Item	No.
8

CITY OF WESTMINSTER			
PLANNING	Date	Classification	
APPLICATIONS COMMITTEE	28 Mach 2017	For General Rel	ease
Report of		Ward(s) involve	ed
Director of Planning		St James's	
Subject of Report	5 Macclesfield Street, London, W1D 6AY,		
Proposal	Replacement shopfront and installation of new awning at front ground floor level.		
	 Display of internally illuminated fascia sign measuring 1.43m x 1.69m, externally-illuminated mural measuring 6.2m x 8.6m to Dansey Place 3.8m x 4.5m to shopfront. 		
Agent	Rolfe Judd Planning		
On behalf of	Shaftesbury Chinatown Limited and Rasa Sayang		
Registered Number	17/01062/FULL and 17/01603/ADV	Date amended/	9 February 2017
Date Application Received	9 February 2017	completed	
Historic Building Grade	Unlisted		
Conservation Area	Chinatown

Refuse planning permission and advertisement consent – design grounds

PROPOSED FACADE ELEVATION 2

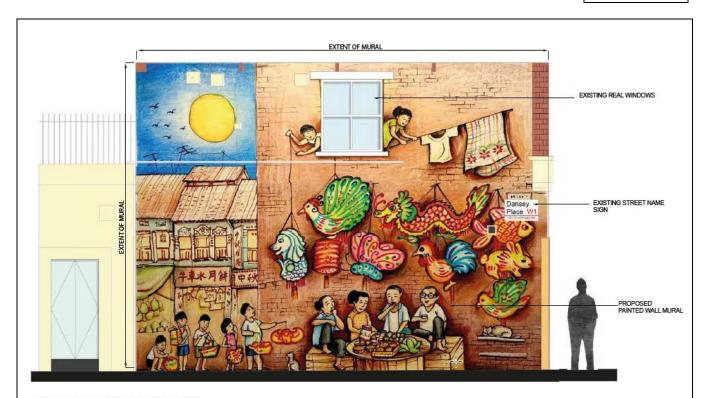
The proportions of the proposed shopfront are considered to be unacceptable. A part of the shop window is proposed to be infilled in order to accommodate the mural. The resulting shopfront has awkward proportions, and an overly narrow window. It does not relate to the proportions of the building above, having a particularly awkward relationship with the window openings.

The proposed stallriser presents no improvement on the proportions or materials of the existing low concrete stallriser. The proposed shopfront is contrary to UDP policies DES 5 and DES9.

The mural on the shop front however is considered to be much more harmful to visual amenity. It forms part of the commercial presence of the shop in the street scene, and results in the entire façade of the shop being covered in advertising.

The proposed fascia sign is unacceptable in design terms. It is a highly unusual shape, being virtually square, and occupying only a small proportion of the shop fascia.

Because of Its proportions and design the proposed shopfront would harm the appearance of this building and fail to maintain or improve (preserve or enhance) the character and appearance of the Chinatown Conservation Area. This would not meet S25 and S28 of Westminster's City Plan (November 2016) and DES 5 (C), DES 1 and paras 10.108 to 10.128 of our Unitary Development Plan that we adopted in January 2007. (X16AD)

Because of its proportions the proposed fascia sign would harm the appearance of the building and the appearance (amenity) of the area. It would also fail to maintain or improve (preserve or enhance) the character and appearance of the Chinatown Conservation Area. This would not meet S25 and S28 of Westminster's City Plan (November 2016) and DES 8 and paras 10.108 to 10.128 of our Unitary Development Plan that we adopted in January 2007. (X15AD)

A mural may be acceptable on the Dansey Place elevation only. The decoration of the front of a building with a mural is unacceptable in principle.
